STATE OF MAINE
DEPARTMENT OF TRANSPORTATION
16 STATE HOUSE STATION
AUGUSTA, MAINE 04333-0016

January 22, 2018
Subject: Billings Bridge
Superstructure Replacement
State WIN: 022618.00
Location: **Paris**
Amendment No. 2

SHEET NUMBER
23
OF 57

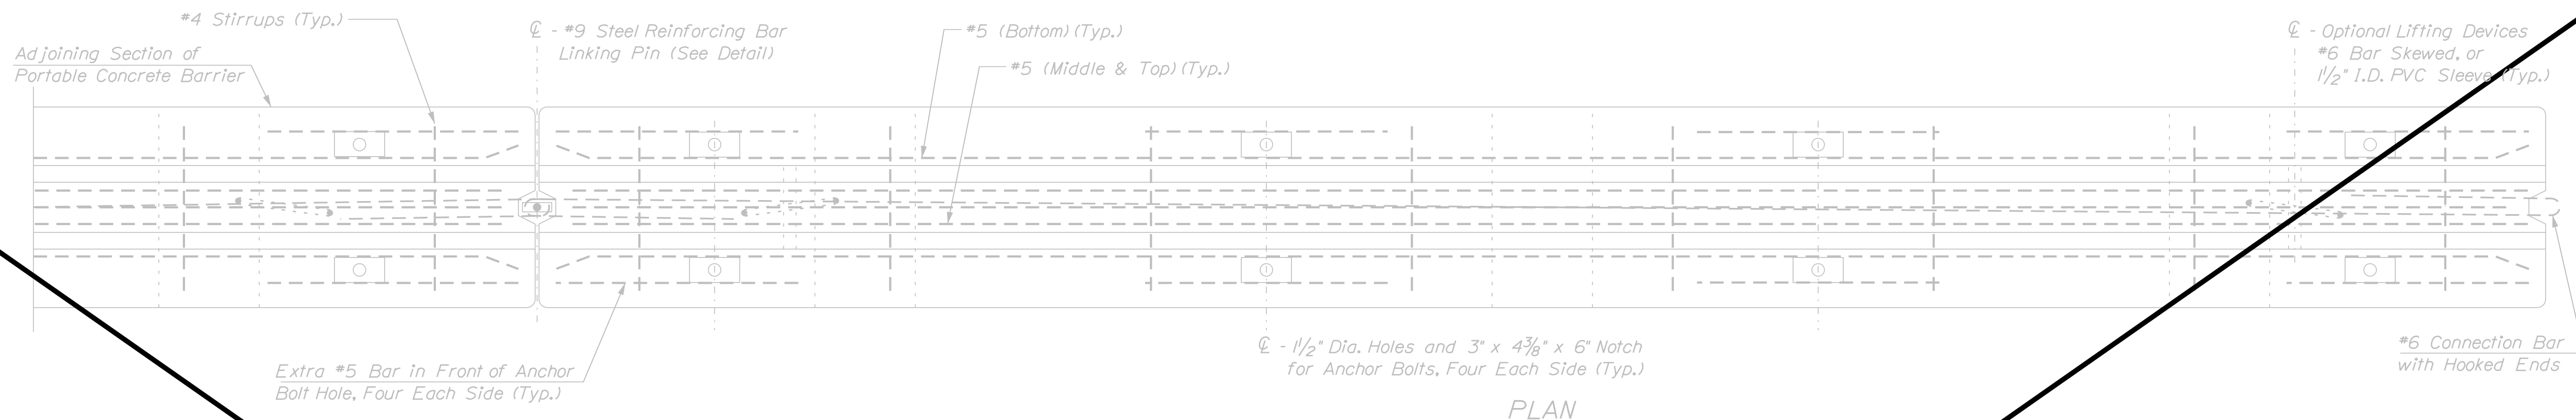
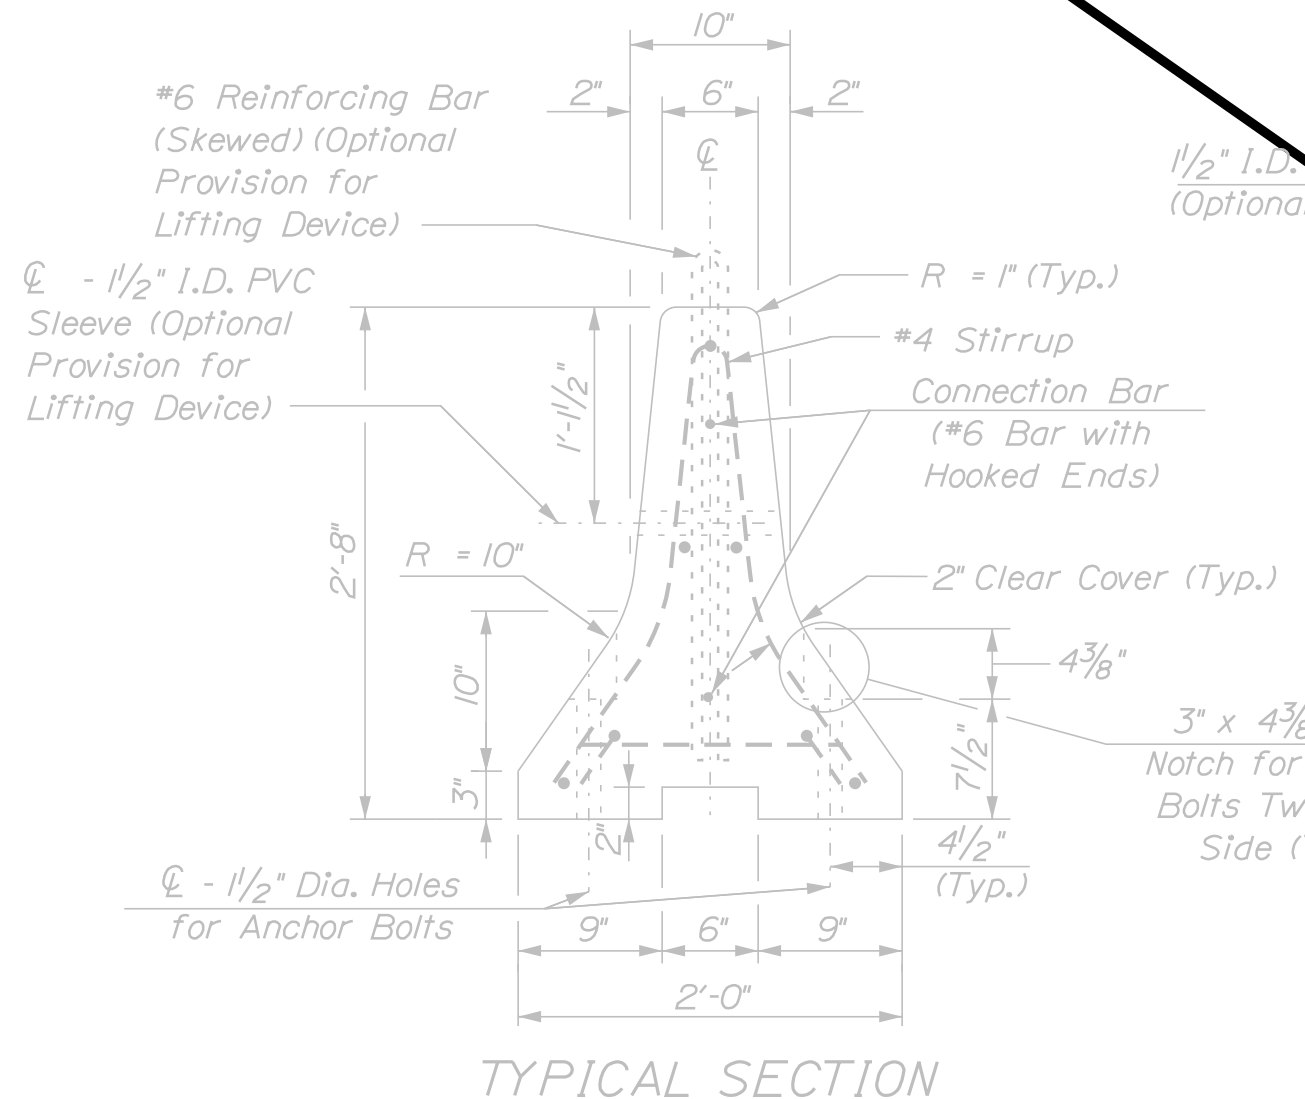
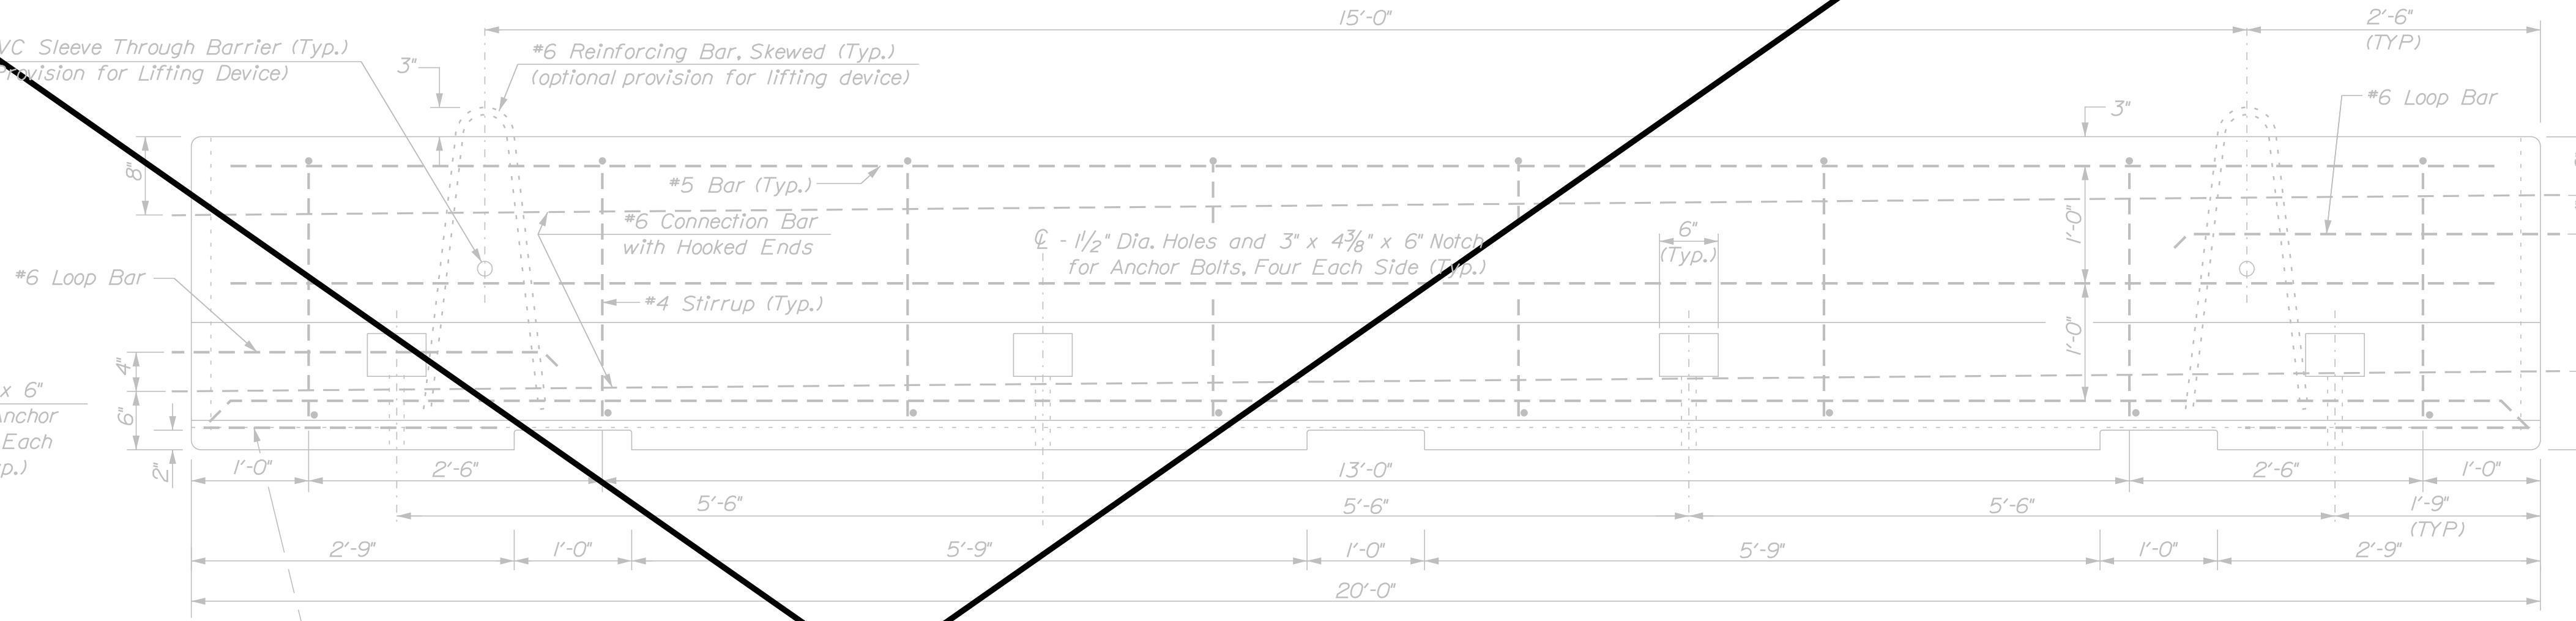
REMOVE SHEET NUMBER 23 OF 57, PORTABLE CONCRETE BARRIER (ANCHORED), and **REPLACE** with the attached, revised SHEET NUMBER 23 OF 57, PORTABLE CONCRETE BARRIER (ANCHORED).

PROJ. MANAGER	J. KITREDE	DATE
DESIGN DETAILED	KCD	11/17
CHECKED/REVIEWED	KW	11/17
DESIGN DETAILED	CSS	
REVISIONS 1	SHEET NOT USED	1/18/18
REVISIONS 2		
REVISIONS 3		
REVISIONS 4		
FIELD CHANGES
